**NC Department of Insurance  
Office of the State Fire Marshal - Engineering Division  
1202 Mail Service Center, Raleigh, NC 27699-1202  
919-647-0000**

**R-30ci vs R38**

**Code:** NC Energy Code  
**Section:** R402.1.2, Table R402.1.2  
**Code:** Residential Code  
**Section:** N1102.1.2, Table N1102.1.2

**Date:** September 16, 2021

**Figure 1: Illustration of Table R402.1.2 Footnote 1 – U-0.032 Btu/hr-ft<sup>2</sup>-°F**

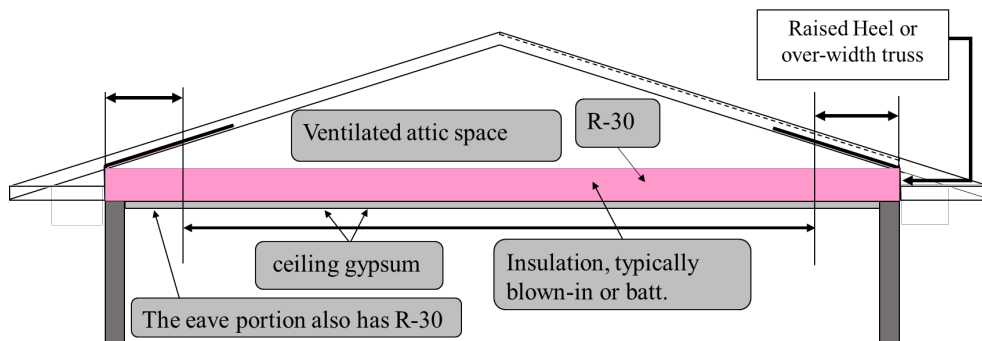
Is it acceptable to use Footnote 1 (“ell”) of Table R402.1.2, which allows R-30 (See Figure 1) in lieu of the base-case R-38 (See figure 3), if the R-30 is rotated up and installed at the roofline (See Figure 2) and the R-30 extends full height to the outer edge of the wall, in Zone 3,4, & 5?

No<sup>i</sup>. When the thermal envelope is rotated up to the roofline, several things change<sup>ii</sup> which make it necessary to slightly increase the R-value requirements so that the overall assembly heat transfer is no worse than the R-30 insulation at the ceiling option. Also, although Section R402.2.2 has an allowance for R-30 in **ceilings without attic spaces**, the allowance is limited to 500 SF, so allowing R-30 in a ceiling without an attic space for an unlimited area **would be in direct conflict with this code section**. However, with slight adjustments in the installed R-value, and several conditions that need to be met based on the type of insulation used, an R-32 value can be used and then the assembly would NOT be limited to only 500 SF. The following method provides a U-factor very close to the U-factor achieved by the R-30 approach of footnote 1, which is U-0.032<sup>1</sup>. If these adjustments in R-value are not made, the actual heat transfer (U-factor) will be worse than the allowance for R-30 at the ceiling level, which is already slightly more than the base case of R-38 in Table R402.2.2, see Figure 3. This scenario can, by interpretation, be used to meet the prescriptive requirements of Table R402.1.2. as it will provide a substantially equal U-factor.

Figure 4: Footnote 1 option rotated up to roof deck-spray foam option – U-0.032 Btu/hr-ft<sup>2</sup>-°F

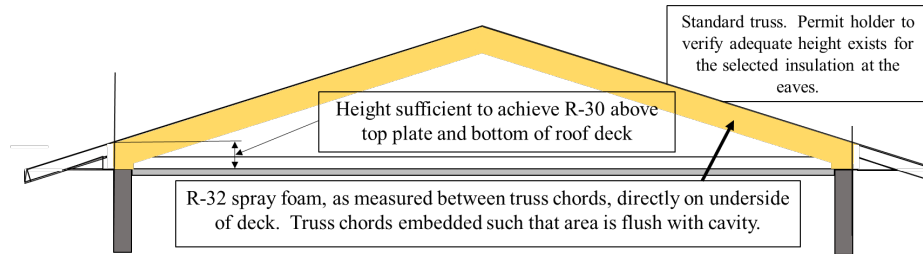
First the spray foam option will be described because it is anecdotally the most common. Table R402.1.2, Zone 3 reads “R-38 or 30ci<sup>1b</sup>”. As discussed in the Background Section of this interpretation, the most commonly requested method does not actually provide R-30ci, but rather a combination of R-30 cavity and a lesser level of ci across the embedded truss chords. In rotating the thermal envelope up to the roof, there are several other variables that change, which necessitate increasing the R-value slightly such that the U-factor, which makes it easier to make comparisons “apples-to-apples”, is essentially equivalent to the Footnote 1 method when the thermal envelope is at the ceiling level.

Therefore, the requirement would be to provide a roof insulation system of R-32 cavity spray foam that meets these requirements:

1. Spray foam applied directly to the underside of the deck such that it is air-impermeable, In accordance with the manufacturer's instructions and the requirements of R806.5, Item 5.1.1
2. There must be sufficient height to allow installing a full R-30 above the wall top plate, as required in Footnote 1 of Table R402.1.2, see Figure 3.
3. The insulation needs to be applied such that the cavities are sprayed to a depth equivalent to R-32, **and** the truss chords need to be embedded in foam such that the area below them is flush with the cavity insulation amount.
4. There may be other conceivable designs, and the user may use the U-factor Table of R402.1.4, or the code paths of Section R402.1.5, R405, or R406.
